Re: PROJECT: Uptown240
ADDRESS: 240 Lake Dillon Drive, Dillon, CO 80435
PERMIT NUMBER: Planning Case Number 2018.001

Architect Respondent: Studio PBA, Inc
Kathy Parker, Project Architect
kparker@studiopba.com
720-376-6845

Below please find narrative responses to your comments dated March 28, 2018 on the above referenced project. Thank you for your review.

1
A021
OVERALL SITE PLAN
1/16" = 1'-0"

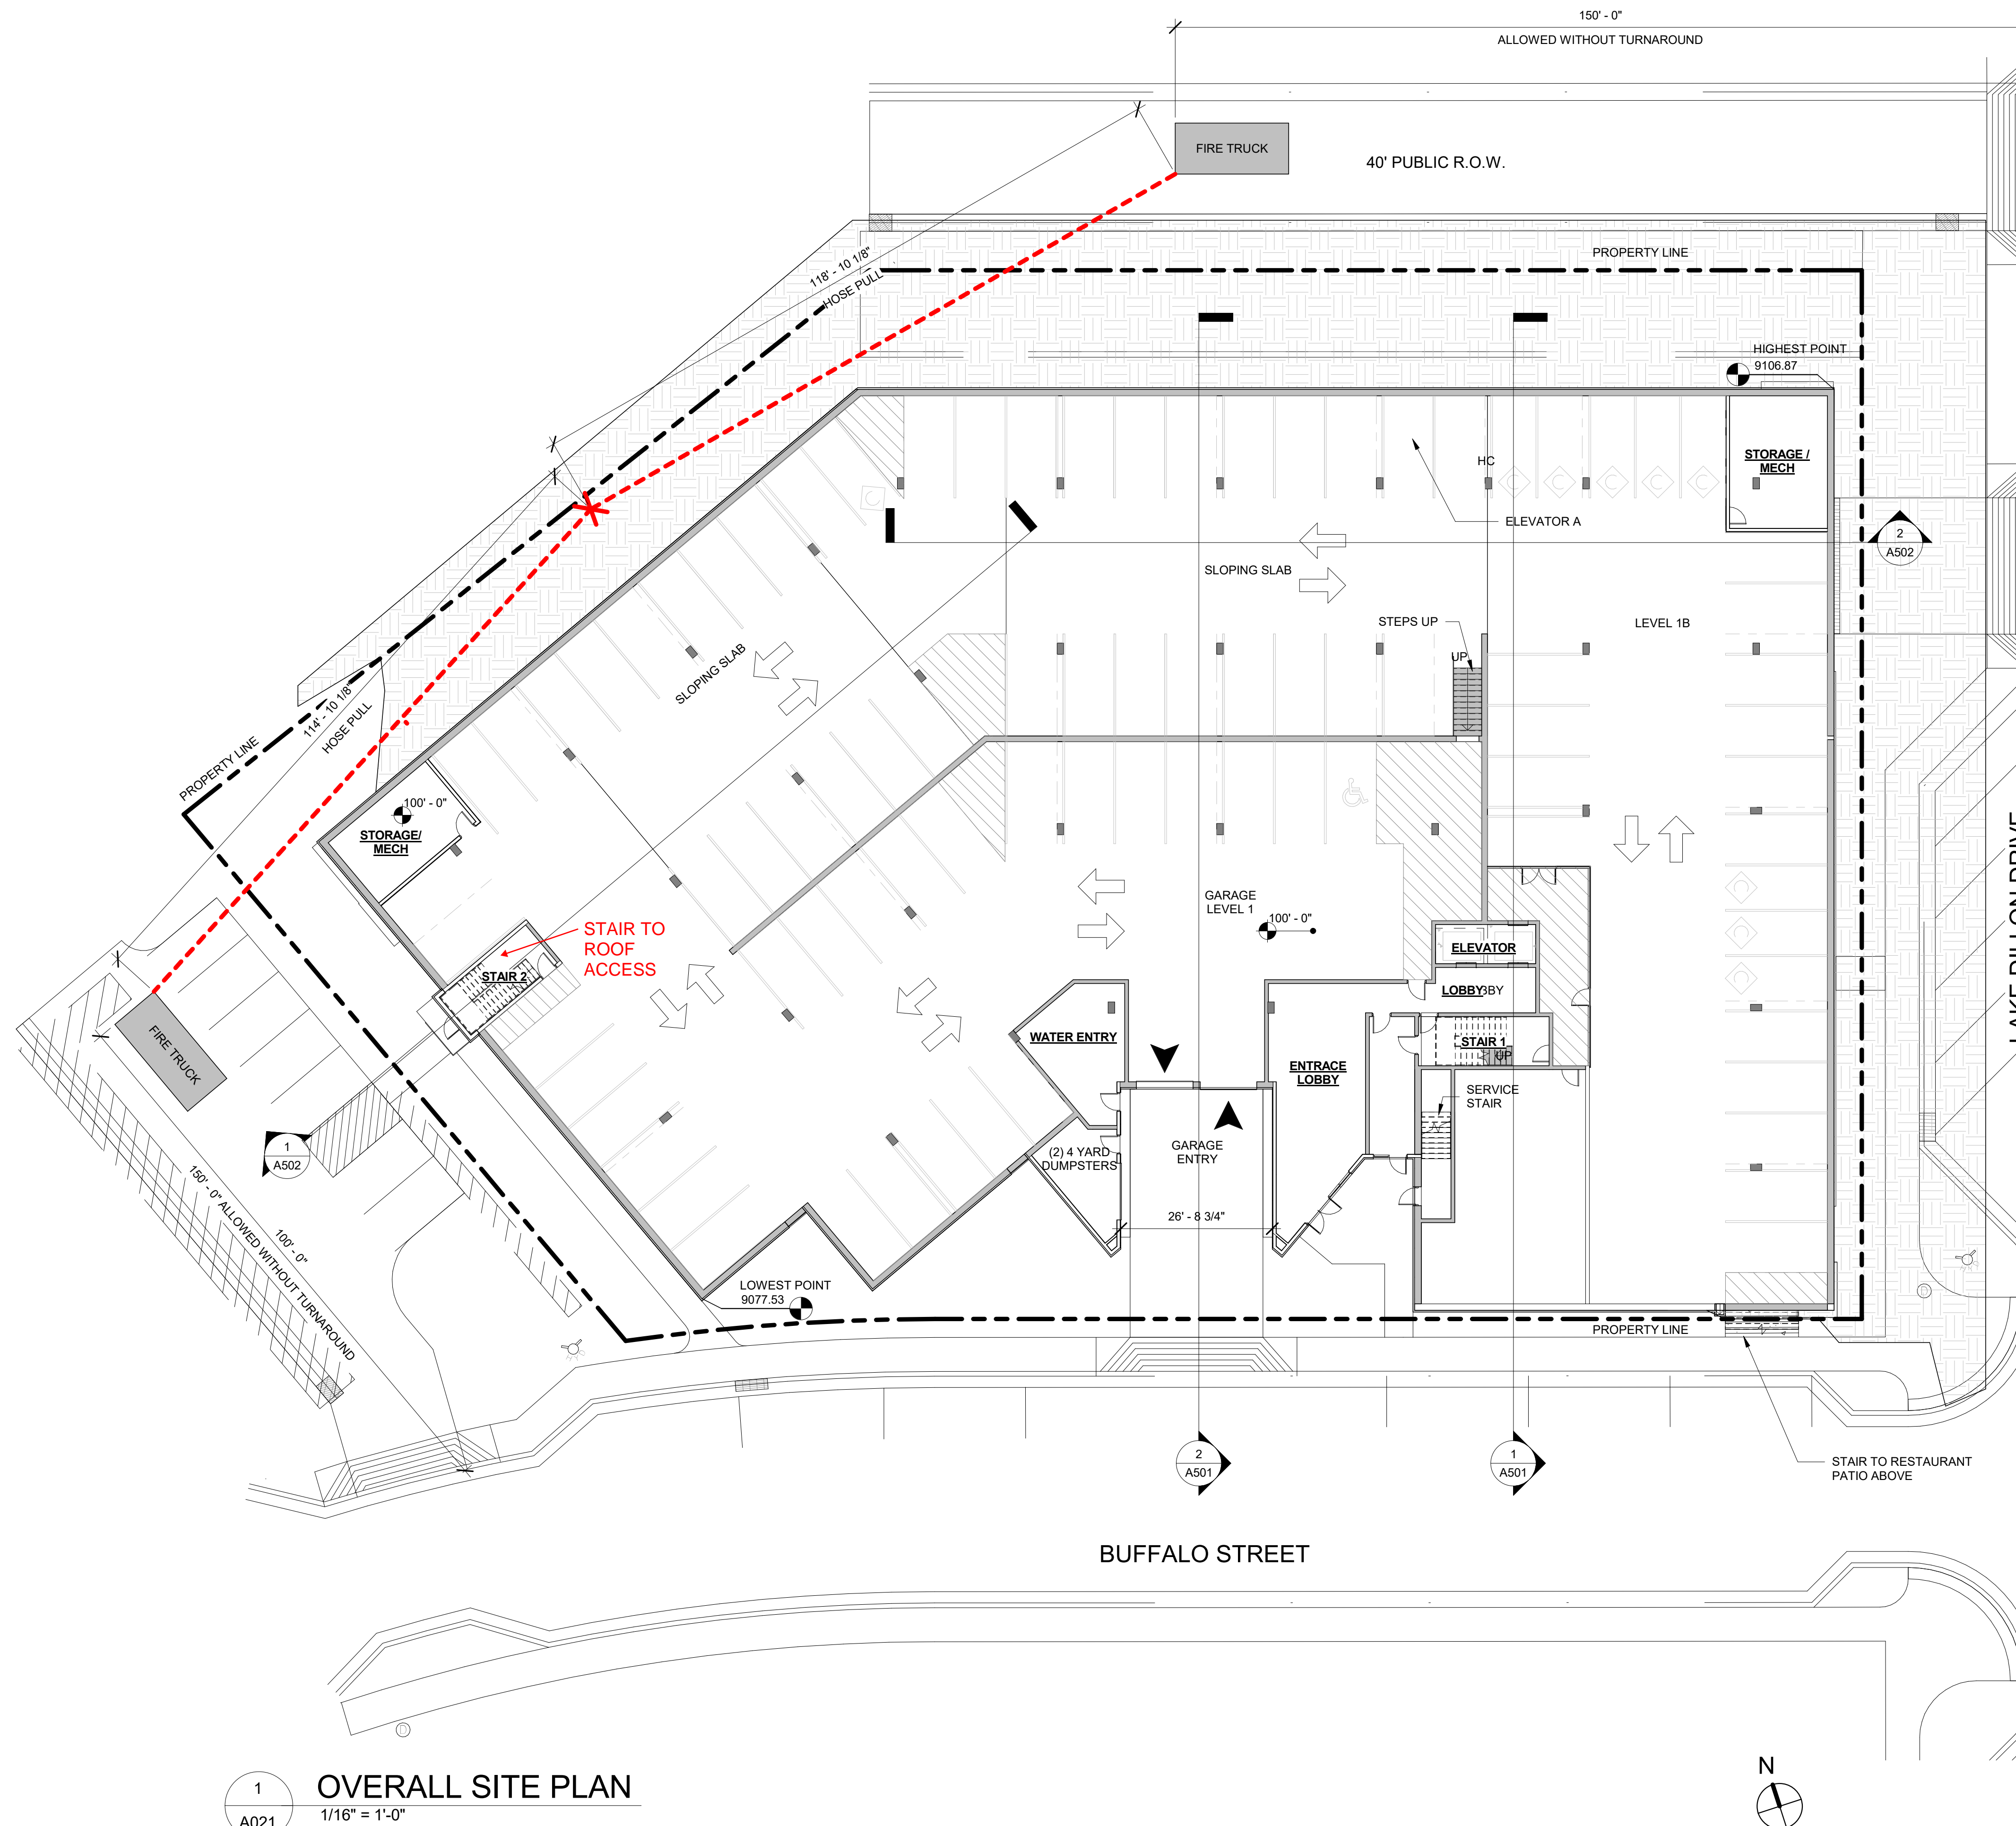
- a. RESPONSE: Drive aisle width will be changed to 26 feet, exclusive of shoulders.
2. As per previous discussions, the aerial apparatus access road on the Northeast side leading from Lake Dillon Drive is greater than 150 feet. Please provide documentation on when a aerial apparatus turn around will be installed.

- a. RESPONSE: See attached Sheet A021 Site Plan which documents that IFC Required Hose Pull distances can be met with a truck driving only 150' down the public ROW on the north side of the building. Therefore, no Turnaround should be required.

A117

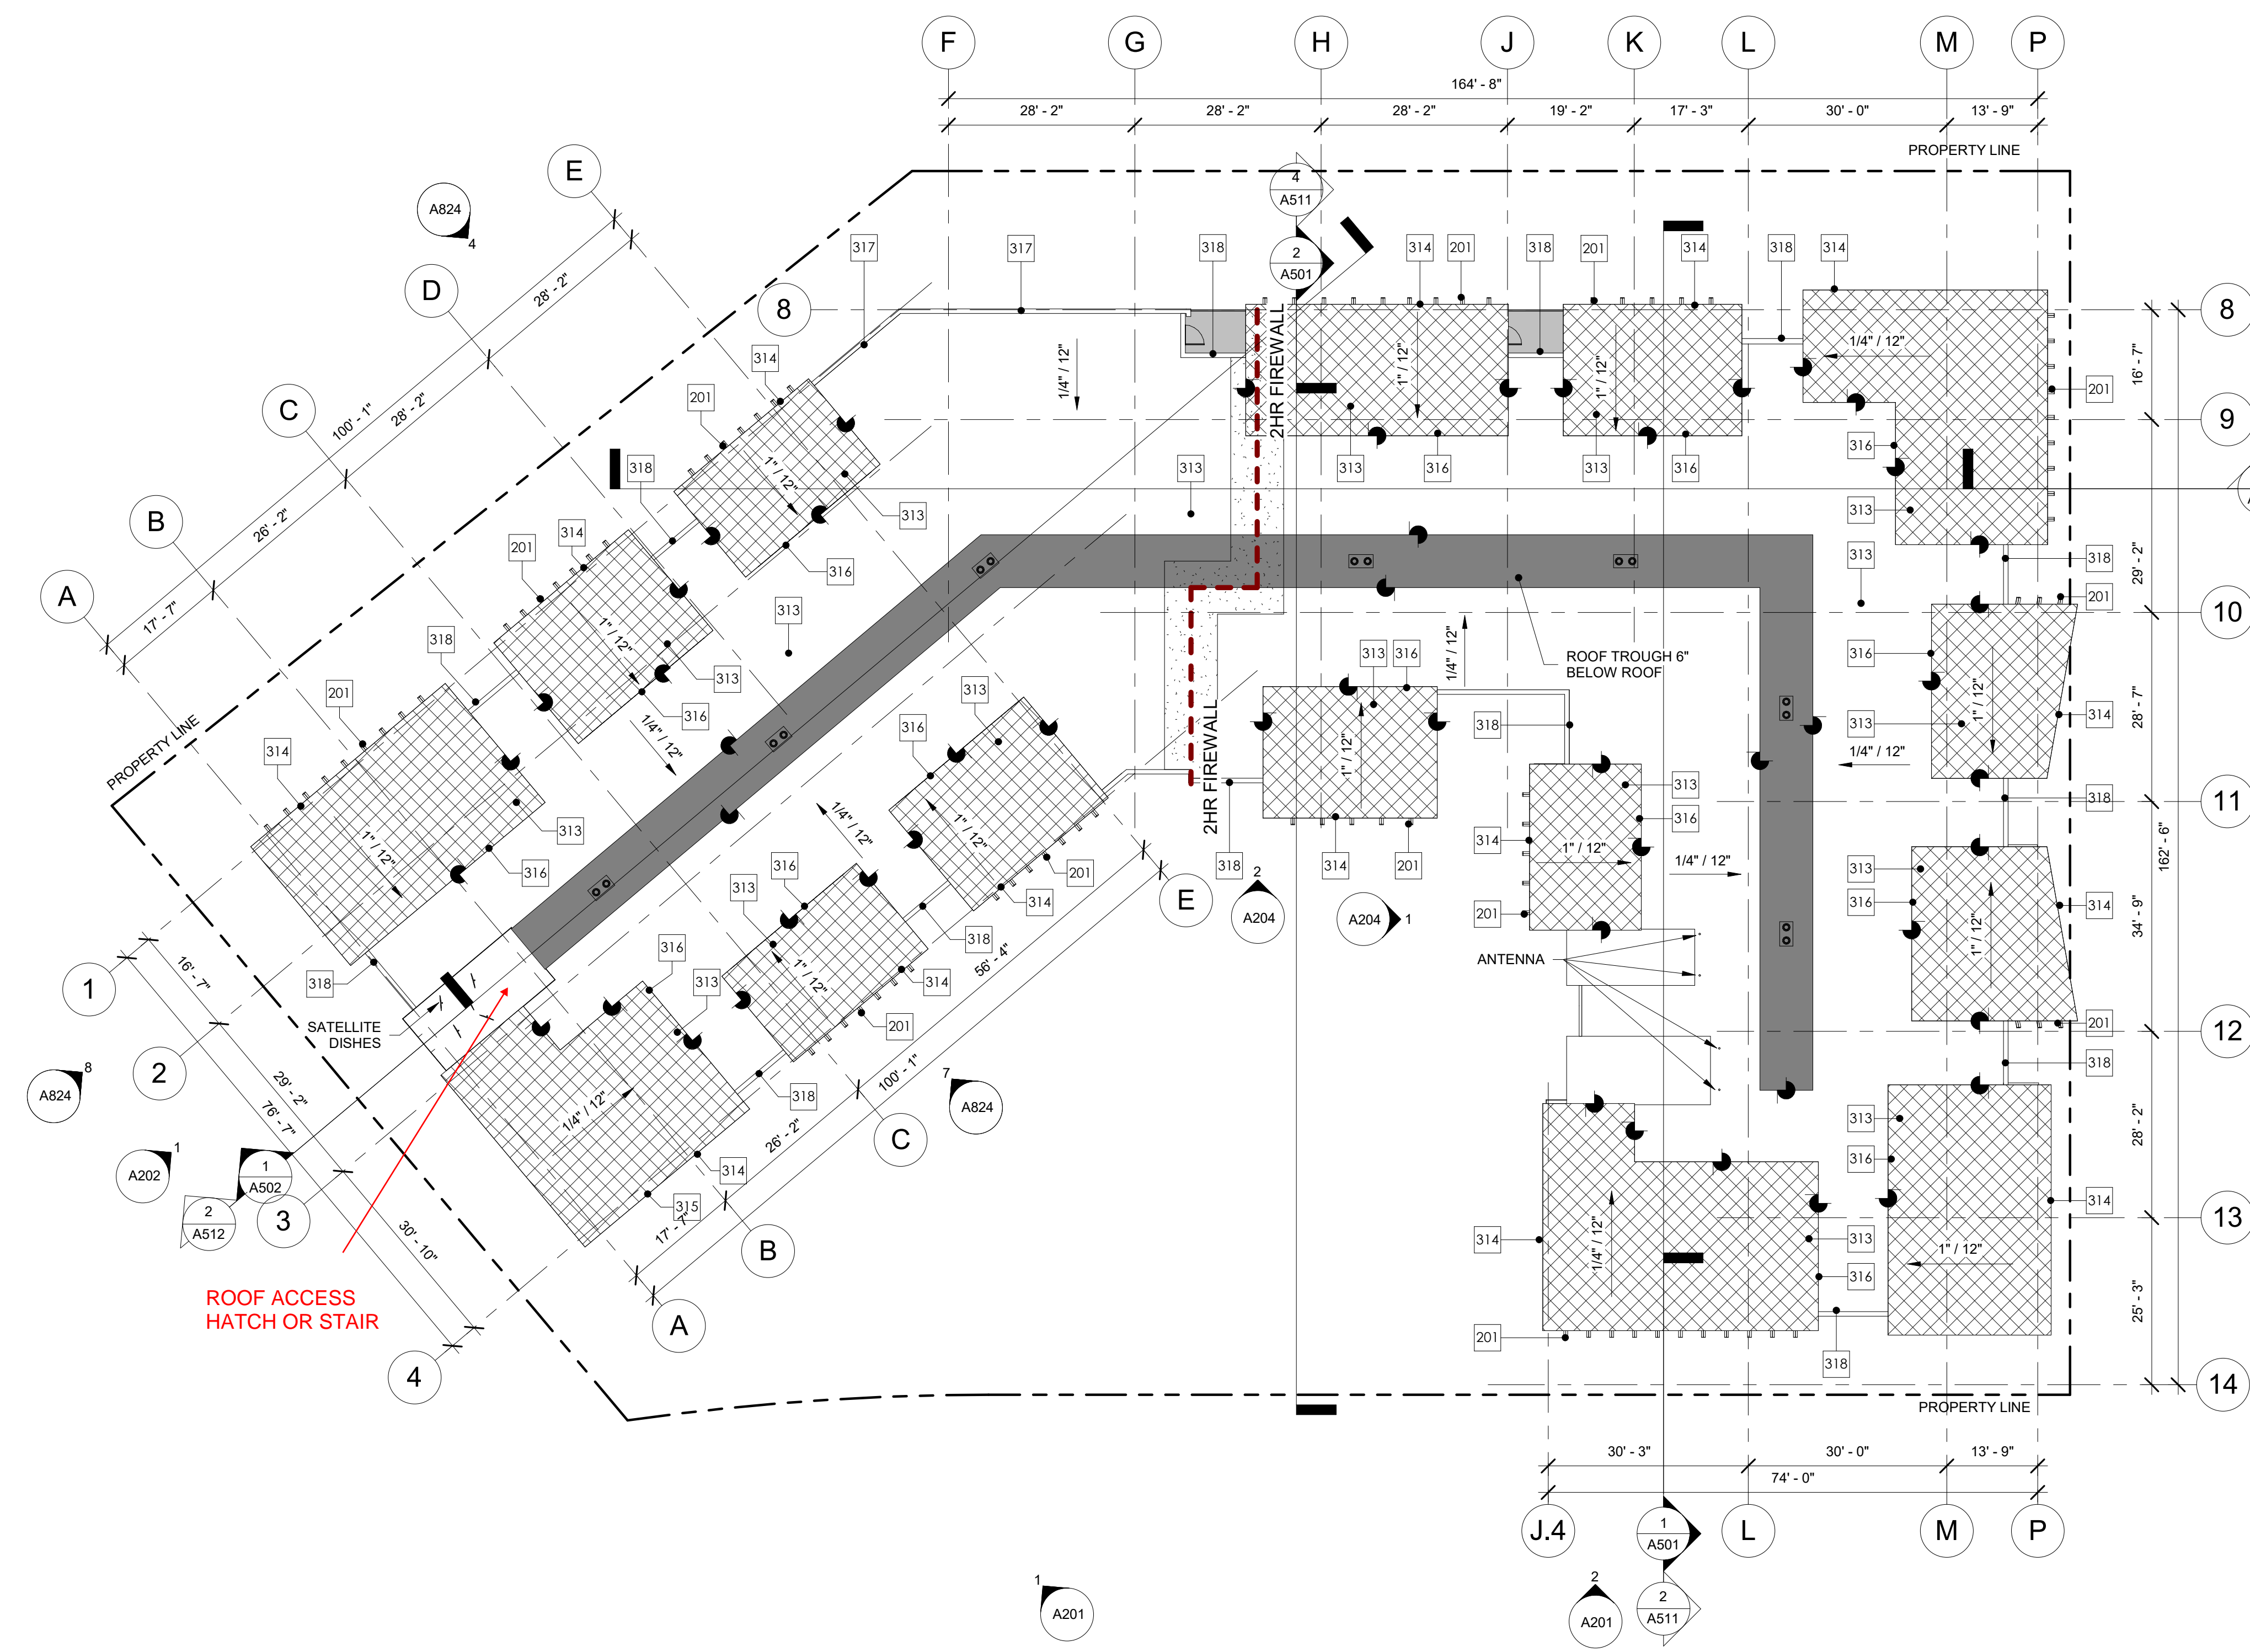
- a. RESPONSE: Noted. We will provide fire lanes and signage where required.
5. On page PUD 104, it does not show which stairs access the roof. Please have the developer provide details on the stairs and roof access.

- a. RESPONSE: Per IBC 2015, 1011.12, in buildings without an occupied roof, a stair all the way to the roof is not required, and roof access can be accomplished via an alternating tread device or ladder through a roof hatch of 16 SF. This hatch will be provided in the roof of Stair #2 (See attached Sheet A021 and A117 Roof Plan for stair location).
However, the developer may choose to provide stair access all the way to the roof surface via roof penthouse.
